INNER WEST

DEVELOPMENT ASSESSMENT REPORT

Application No.	DA/2020/0815
Address	120C Old Canterbury Road SUMMER HILL NSW 2130
Proposal	Construction of an 8-storey mixed-use development comprising ground level retail, 57 residential units, three levels of basement car parking and a pocket park
Date of Lodgement	28 September 2020
Applicant	Mr Conrad GT Johnston
Owner	Mr Tyron P Timperi Mr Rick Timperi
Number of Submissions	Initial: 18
Value of works	\$31,194,000.00
Reason for determination by Planning Panel	General development with a capital investment value over \$30 million
Main Issues	ADG non-compliance, variation to maximum FSR, Flooding, Impacts to greenway/biodiversity, access over Hawthorne Canal
Recommendation	Deferred Commencement consent
Attachment A	Recommended conditions of consent
Attachment B	Plans of proposed development
Attachment C	Clause 4.6 Exception to Development Standards

Figure 10 – Separation distance resultant from Light Rail Line.

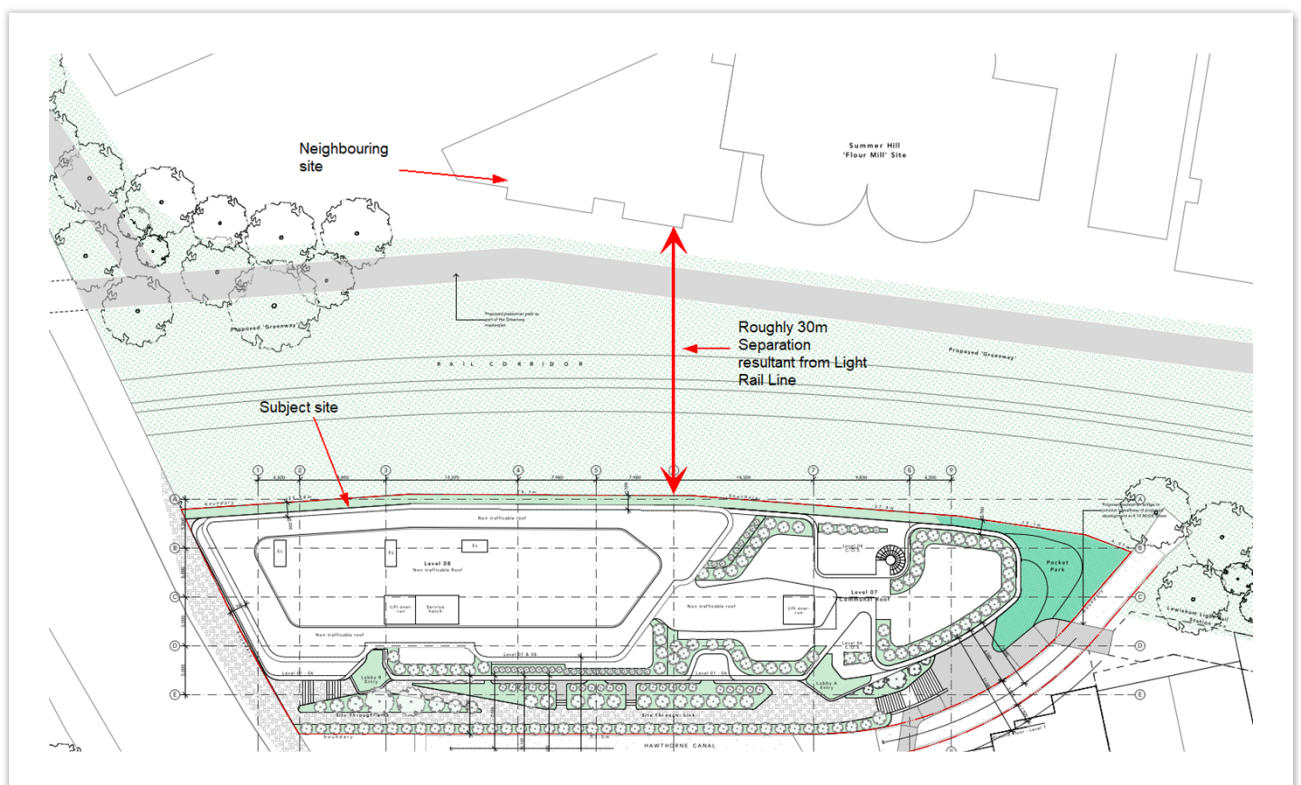
The proposed western side boundary setbacks for residential units on levels 1 – 8 incorporates a variation to the ADG required 9m setback to habitable rooms, with units in this locality to incorporate a 1.5m boundary setback. The intention of this control is to ensure adequate building separation distances between sites and to ensure that they are shared equitably in order to provide reasonable external and internal privacy.

The subject site immediately adjoins the Inner West Light Rail Corridor along the western boundary. This rail corridor creates a significant separation distance of roughly 30m between the subject site and opposite residential properties located on the eastern boundary of the light rail line. This is best illustrated through figure 10 below. The 30m separation distance resultant from the rail buffer ensures that the subject development and neighbouring residential sites achieve a separation outcome which is more than the minimum required by the ADG and provides generous opportunities for sites to obtain and maintain reasonable external and internal privacy. A review of the neighbouring Flour Mill development has highlighted that these structures currently enjoy a similar reduced side boundary setback, like that currently proposed by the subject development. In this instance strict compliance with the minimum side boundary setbacks is unlikely to substantially improve visual privacy for residents or further minimise any impacts of bulk and scale, as this is already been achieved through the light rail corridor. It is anticipated that amenity impacts from the 1.5m proposed boundary setbacks will be minimal and in-line with that of a high-density urban environment expected within the locality. As such the proposed variation is acceptable and recommended for support.

Figure 11 – External privacy hoods to units detailed in blue cloud.

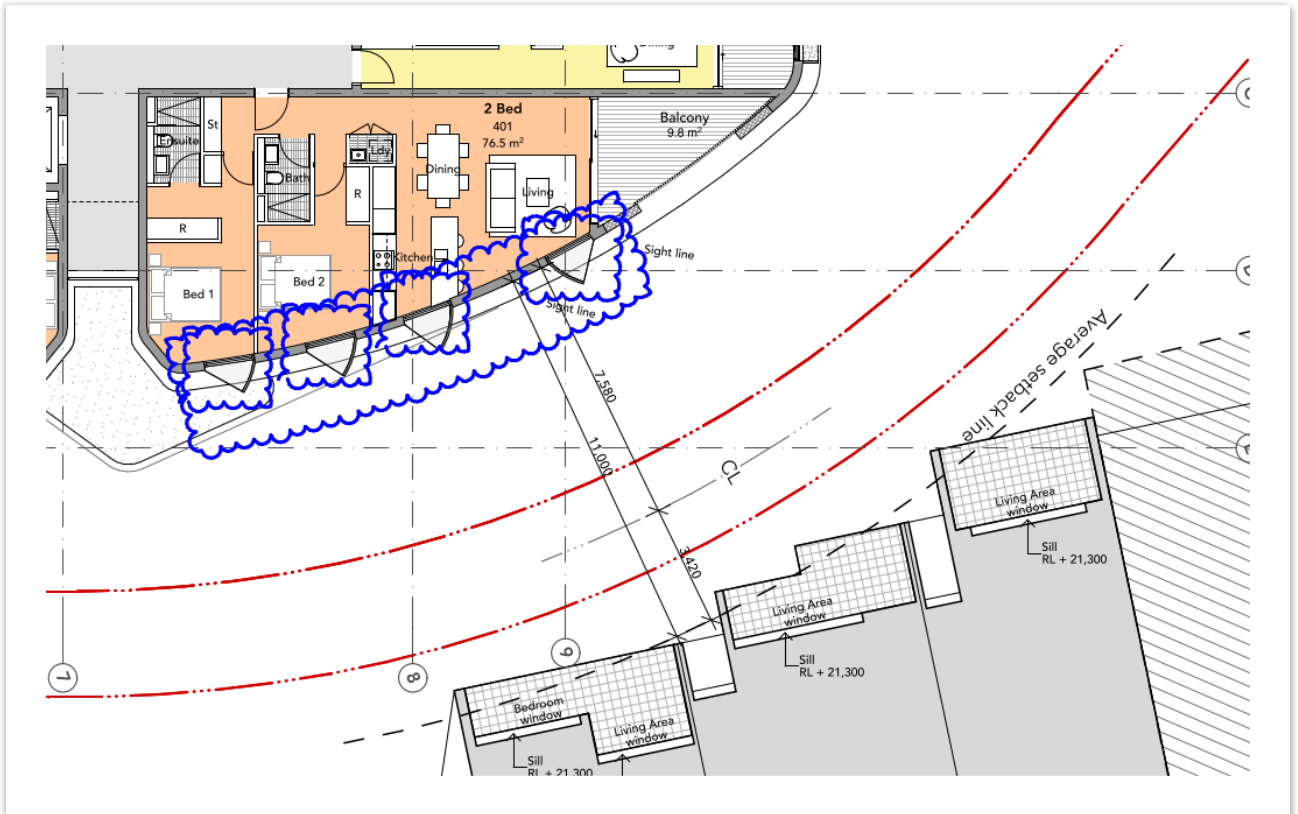
The proposed north east corner setback variation is compounded by the recently constructed 14 McGill Street which utilises substantially reduced boundary setbacks of 3.4m and results in both developments having a total separation of only 11m (not the 18m intended by the ADG). In this instance the non-compliance with separation is largely resultant from both parties (subject site and 14 McGill Street) not sharing separation requirements.

Due to the location and siting of 14 McGill Street, strict compliance with the prescribed 9m setback for the subject site is unlikely to substantially improve internal or external privacy. As such, enforcement of strict compliance has been deemed unreasonable in this instance. Instead a focus has been applied to occupant amenity and mitigation of any potential impacts. Following discussions with the applicant it has been determined that this means of occupant amenity is best achieved through the installation of privacy treatments to windows to the following units: 301, 401, 501 & 601. These privacy treatments have taken the form of external window hoods, as seen in figures 11 and 11(a) below. The design of these hoods have been reviewed and are considered to be acceptable to ensure amenity and privacy. The design of the hoods on an angle ensures minimal opportunities for direct sightlines into or from the proposed units, while maintaining sufficient opportunities for light and ventilation into the rooms the windows relate to.

Figure 13 – Model of built form envelope proposed under current development application. Note elements within red circle on lower ground floors are now residential accommodation/ GFA.

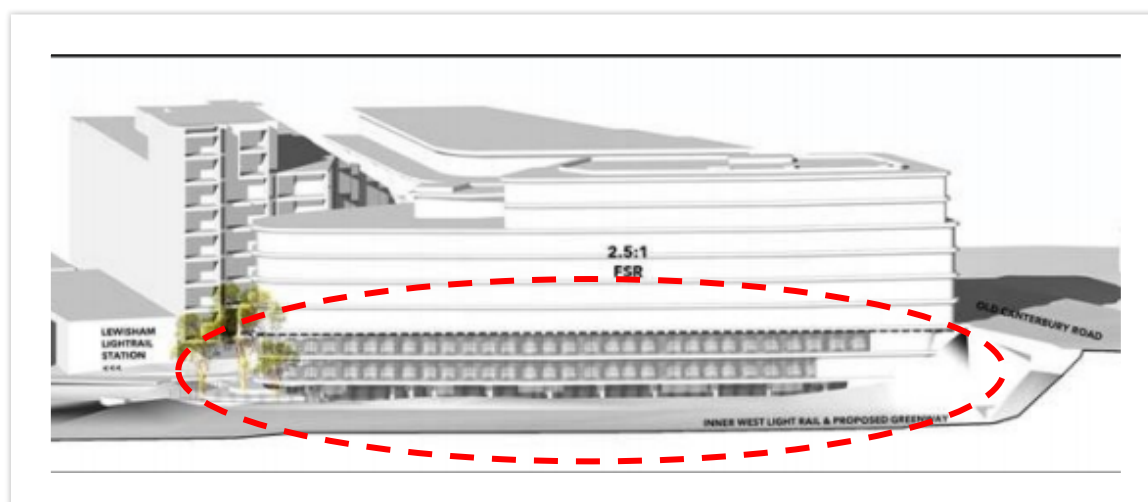
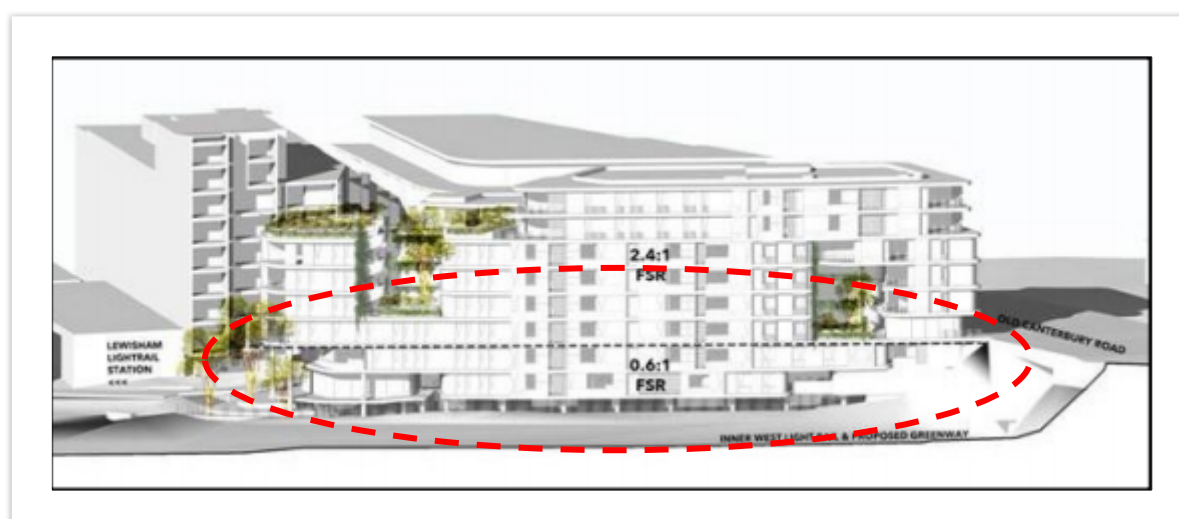
The applicant seeks a variation to the Floor Space Ratio (FSR) development standard under Clause 4.4 of the ALEP 2013 by 20% (979 sqm). This variation to FSR is directly attributed to the lower two levels of the development, which under the planning proposal were designated to cater for above ground car parking. Since the time of the planning proposal the application has been amended (based on new flooding advice) and now incorporates basement car

parking. The provision of basement car parking has enabled the creation of additional residential accommodation/retails spaces within levels 1 and 2, previously to be solely utilised for above ground parking. This is best illustrated within figures 12 and 13 below.

The applicant's written rationale adequately demonstrates compliance with the development standard is unnecessary in the circumstances of the case, and that there are sufficient environmental planning grounds to justify contravening the development standard.

Figure 14 – Location of new vehicular and pedestrian bridges to be constructed over Hawthorne Canal.

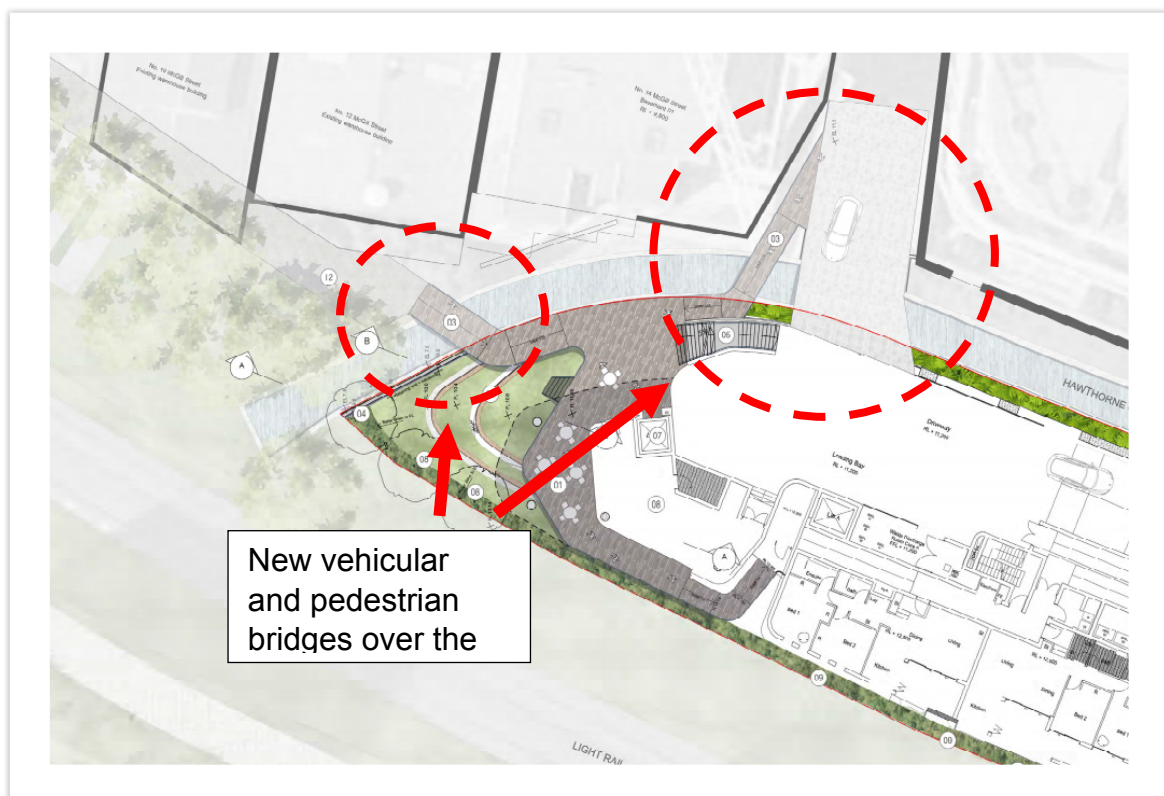
The vehicular and pedestrian bridges identified in figure 14 (over Hawthorne Canal) are subject to flooding, with the flood report submitted by the applicant detailing that it:

would become unsafe for small vehicles to drive across the bridge when the depth of floodwaters across the driveway exceed 0.3 m (which would occur before the peak of a 100 yr ARI flood). It is estimated that it would become unsafe for large vehicles to drive across the bridge when the depth of floodwaters across the driveway exceed 0.5 m at around the peak of a 100 yr ARI flood.

This extent of flooding to the proposed pedestrian bridges has been reviewed by Council's Development Engineers who raised no objection to the bridges subject to Sydney Water providing consent for construction and compliance with Sydney Water requirements. In this instance Council's Development Engineer has outlined that, subject to suitable conditions of consent, that the development site will have adequate refuge points from flood waters on-site and that there is no requirement for occupants to cross the bridges during a flood event. Furthermore the final point of access to the site (as seen within figure 15) is directly off Old Canterbury Road, unlike the other two bridges detailed within figure 14 this access point is not located over Hawthorne Canal and is not subject to potential flooding. Therefore, this access point can be used during a flood event regardless of water levels and ensures a permanent and safe exit location from the site during a flood event.

Figure 16 – Location of existing pedestrian and vehicular bridges at 6 Smith Street, Summer Hill.

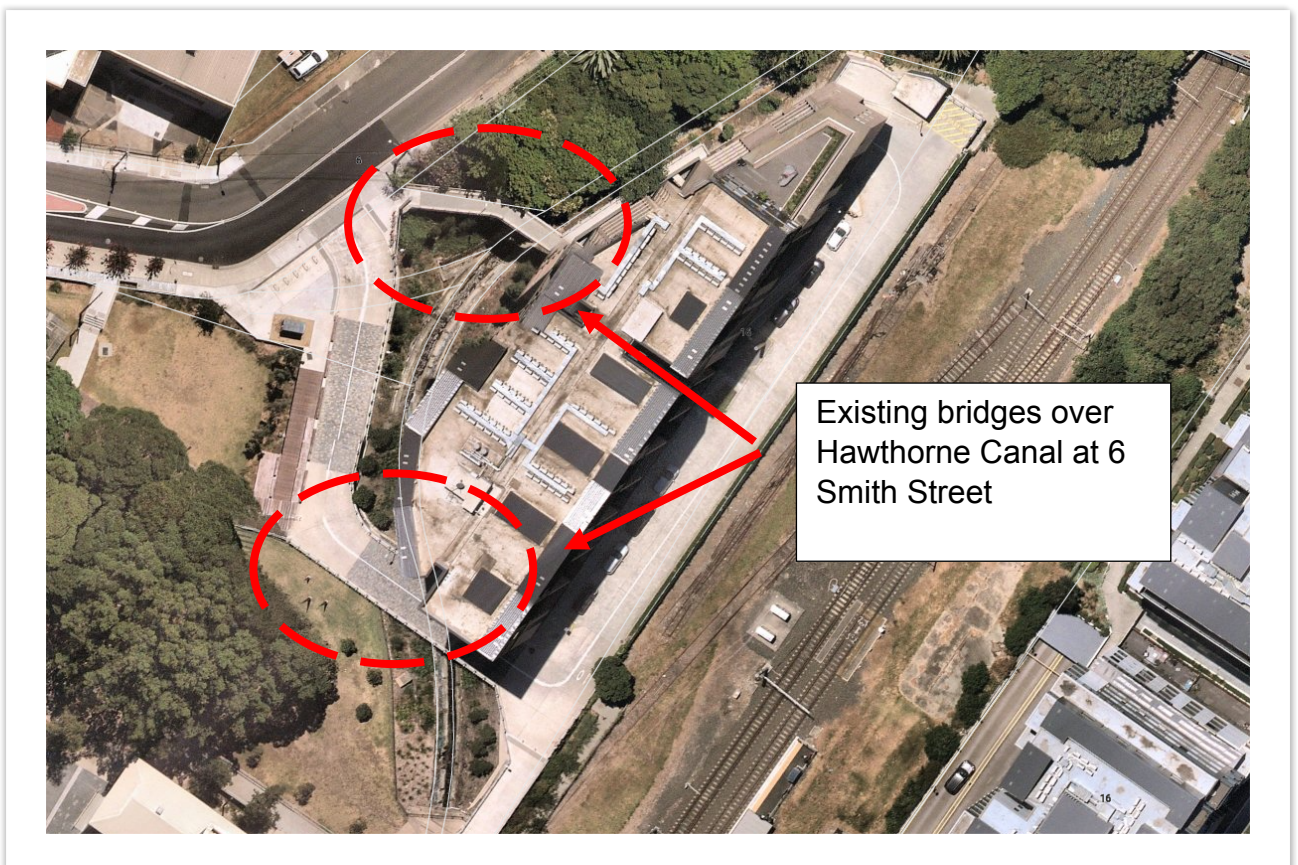
During the current assessment process the application has been referred to Sydney Water for comment. Sydney water initially outlined that there is insufficient information regarding the bridges to determine if they comply with the construction requirements for buildings over/adjacent to a stormwater channel and outlined an objection to the two new pedestrian bridges to be constructed over the canal. Following the submission of these comments, Council staff contacted Sydney Water and discussed the matters further. During this

discussion Council staff highlighted similar recently constructed bridges servicing the development at 6 Smith Street (see figure 16 below) and highlighted the strategic importance of allowing the creation of the new pedestrian bridges. In response Sydney Water outlined their construction requirements for bridges over Hawthorne Canal and stated that they have no objection to the new bridges over the Canal given their strategic importance to the locality, subject to the creation of a suitable legal agreement regarding access, maintenance and use of the structures. To be satisfied that the proposed development is able to be adequately serviced and that a legal agreement for use of the bridges over Hawthorne Canal is in place a Deferred Commencement condition requiring Council to be satisfied that Sydney Water have provided agreement for all bridge structures over Hawthorne Canal including public rights of way or access agreements for use by the public is recommended.

The construction requirements for the proposed bridges over the canal have been passed on to the applicant, who has since provided documentation showing how the bridges can be constructed to generally comply with the requirements and still adequately service the development. Final details of the bridge design are to be completed prior to a construction certificate and in conjunction with Sydney Water. As part of their comments Sydney Water have provided recommended conditions of consent should the proposal be approved, these conditions have been incorporated into the recommended conditions of consent and should form part of any approval.

Figure 19 – Site specific DCP control diagram

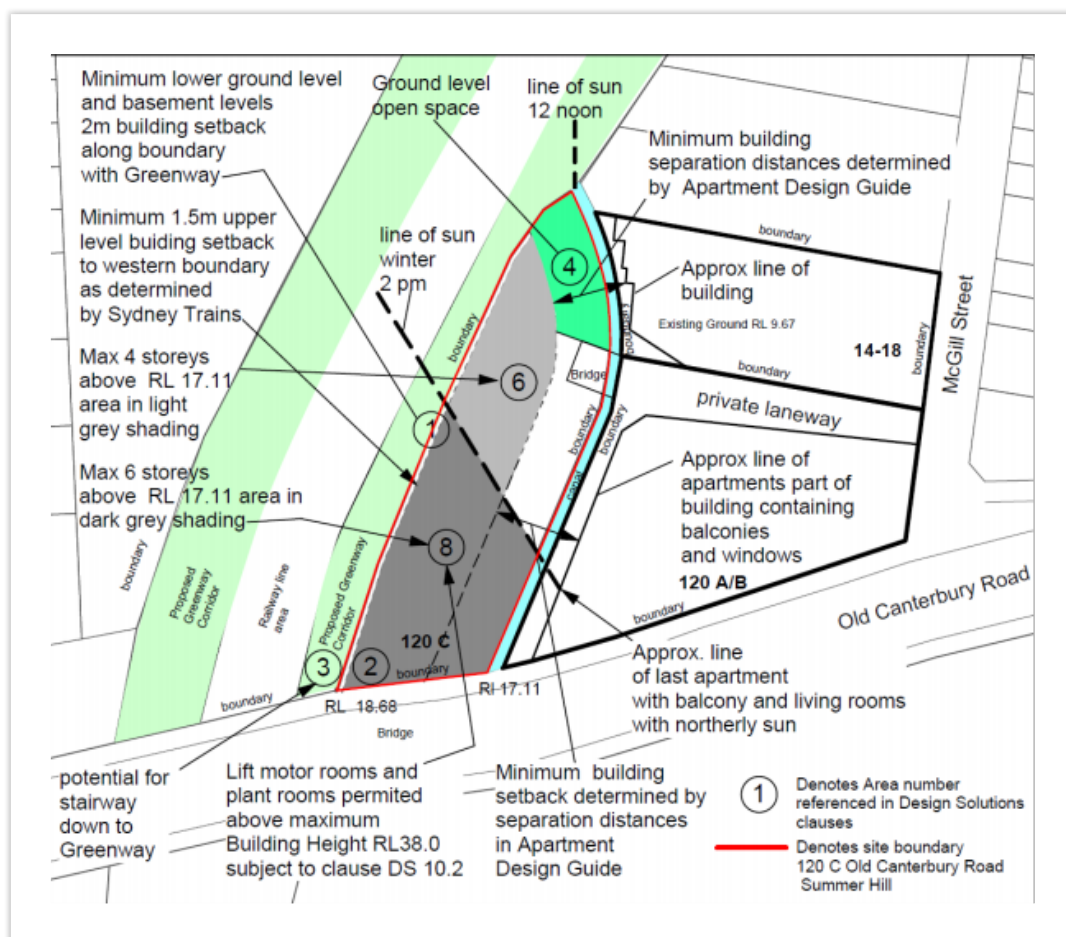
As a result of the planning proposal PP_IWEST_105_00 the subject site has had site specific DCP controls created under Chapter D – Precinct Guidelines within the IWCDP 2016. These controls are best contextualised through figure 19 below. Since the creation of the site specific DCP control the proposal has undergone numerous revisions and further investigations with regards to flooding and biodiversity. These amendments have resulted in an alternative scheme currently sought by the applicant. An assessment of the proposal's variations to site specific DCP controls is undertaken below:

A review of clause DA 1.2 within Part 13 of Chapter D has highlighted that the DCP calls for the development to have a 2m wide landscape strip along the boundary shared with the light rail line. The intention of this setback is to be for the provision of vegetation to enable “green walls” to cover the previous envisioned above ground car parking structure (as detailed within figure 12 above). The current application seeks a variation from this control and proposes to only provide a 1.5m setback to the western boundary.

As seen within figure 19 below the current proposal has relocated the required through site pedestrian link from the western boundary (sought by current DCP controls) to the eastern boundary. This relocation of the through site link results in a more efficient use of space and ensures a high degree of passive surveillance to all areas of public domain within the locality, Greenway included. The proposed location of the through site link provides greater opportunities for the provision of deep soil landscaping and utilisation of space required for separation distances. The proposed through site link relocation is expected to have minimal impact on neighbouring properties amenity and is readily viewed by residential units. The proposed location of the through site link maintains the objectives of the control which is to promote pedestrian access and provide opportunities for landscaping. The proposed variation is acceptable and recommended for support.

Following the submission of additional flooding advice this above ground carparking has now been converted to basement carparking, with level 01 and 02 now amended to incorporate residential units. The replacement of this above ground car parking with residential units provides an improved urban design and public domain outcome for the greenway/light rail interface and ensures greater visual interest and passive surveillance in the locality. This improved visual interest removes the requirement for screen planting.

Instead, this 1.5m western boundary setback is proposed to be planted out with native grasses, native shrubs and numerous bat boxes and bandicoot shelters to accommodate and cater for ecologically significant communities who may in the future utilise the locality for habitation. This alternative solution to the 2m setback requirement is considered to meet the objectives of the clause through the continuation of vegetation and native wildlife habitats, while also providing an improved urban design outcome for the locality. The proposed variation is therefore considered to be meet the intention of the controls and worthy of support.
